XLCH MODEL FUSE ELIMINATED

HARLEY-DAVIDSON MOTOR CO.

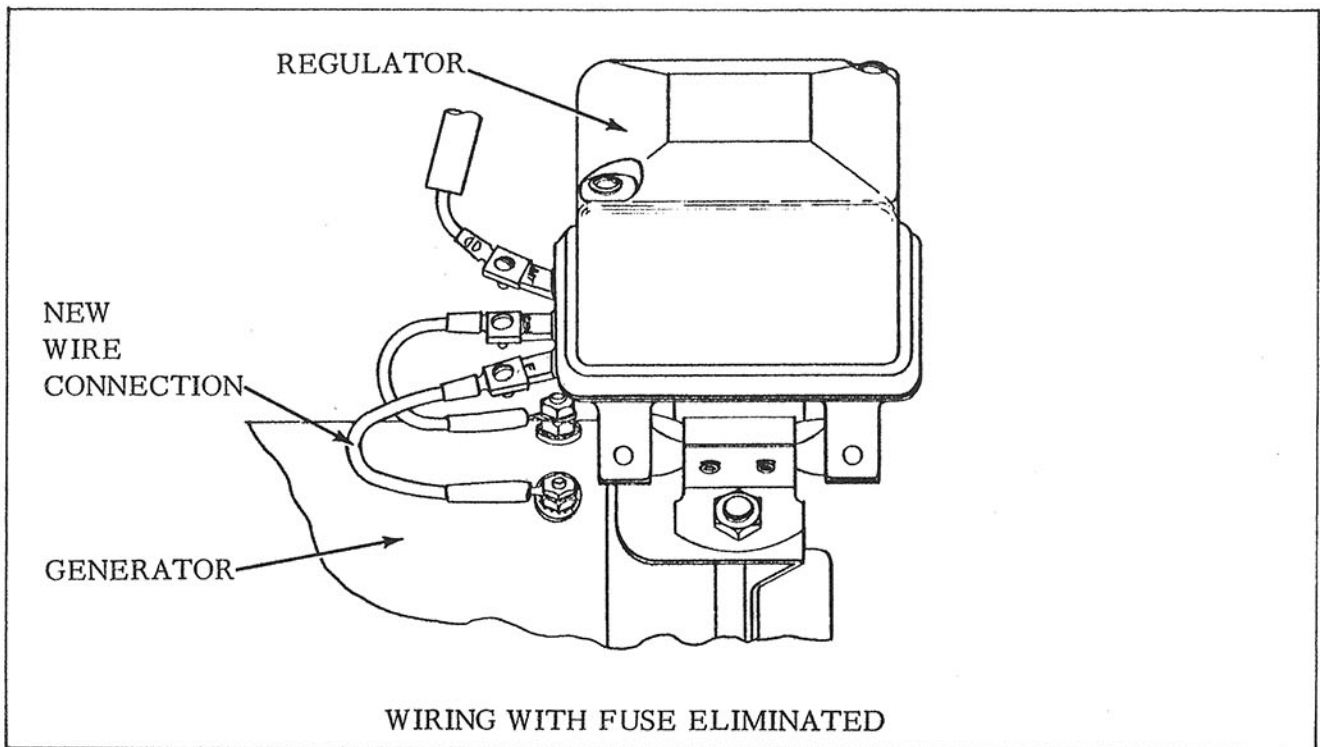
The fuse located at the base of the Sportster XLCH voltage regulator has been eliminated on all Sportster XLCH motorcycles shipped from the factory starting September 21, 1961 with Engine No. 62 XLCH 2481.

It is recommended that this modification be made on all magneto equipped Sportster XLCH motorcycles in the field to make the electrical system more reliable.

Disconnect the green wire with fuse and fuse holder and substitute a short wire, Part No. 70251-52, directly between the generator field (F) terminal and the regulator field (F) terminal. See diagram.

If short wire is not available, cut the green wire off approximately 1-1/2 inches from each end terminal, splice wire ends and tape spliced connection to insulate it.
